Access Compliance Report

Public Rights-of-Way

Intersection ID: 3067	Main Street: HEDGE_MAPLE_RD	Cross Street: PLACER_MAPLE_LN	Location:	N
ADA ID: 09EB5AFB44A7	Ramp Type: Perp	Initial Pass/Fail: Fail	Overall Compliance: No	Severity Score: 10
Codes/Mitigation Info/Possible Solution		Field Measurements/Component Compliance

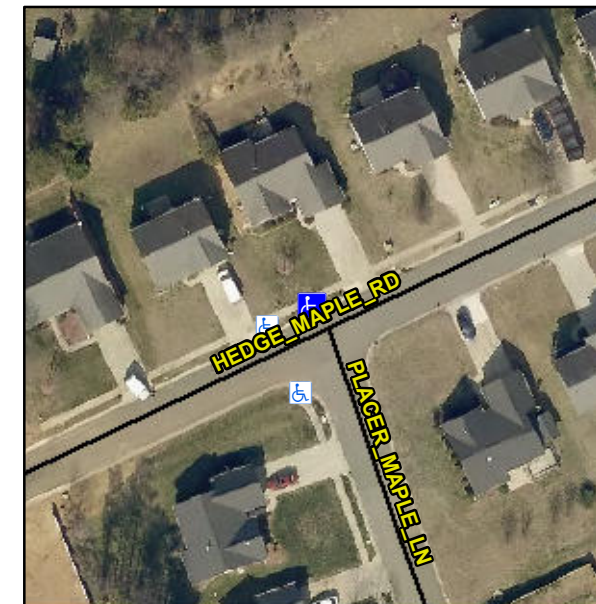
Not Found, R304.5.1, R304.5.3

Compliance	Description	Data	Compliance	Description	Data
N/A	Ramp Length (in)	49.0	Yes	Ramp Slope (%)	6.8
No	Ramp Width (in)	44.0	No	Ramp XSlope (%)	4.2
N/A	Flare Type LT	N/A	N/A	Flare Type RT	N/A
N/A	Flare Slope LT (%)	N/A	N/A	Flare Slope RT (%)	N/A
N/A	Flare Traversable LT?	N/A	N/A	Flare Traversable RT?	N/A
N/A	Landing Length (in)	N/A	N/A	DWS Provided?	N/A
N/A	Landing Width (in)	N/A	N/A	DWS Contrast?	N/A
N/A	Landing Slope (%)	N/A	N/A	DWS Length (in)	N/A
N/A	Landing X Slope (%)	N/A	N/A	DWS Full Width?	N/A
N/A	Landing Curb? (Y/N)	N/A	N/A	DWS Offset (in)	N/A
N/A	Shared Landing?	N/A			
N/A	Gutter Ponding?	N/A	N/A	Gutter Slope (%)	N/A
N/A	Gutter Lip Ht (in)	N/A	N/A	Gutter X Slope (%)	N/A
N/A	Painted X Walk1?	No	N/A	Painted X Walk2?	N/A
	X Walk 1 Direction	To SW		X Walk 2 Direction	N/A
N/A	X Walk 1 Width (in)	N/A	N/A	X Walk 2 Width (in)	N/A
	X Walk 1 Slope (%)	2.6		X Walk 2 Slope (%)	N/A
	X Walk 1 X Slope (%)	4.1		X Walk 2 X Slope (%)	N/A

Remove & Replace Entire Ramp.
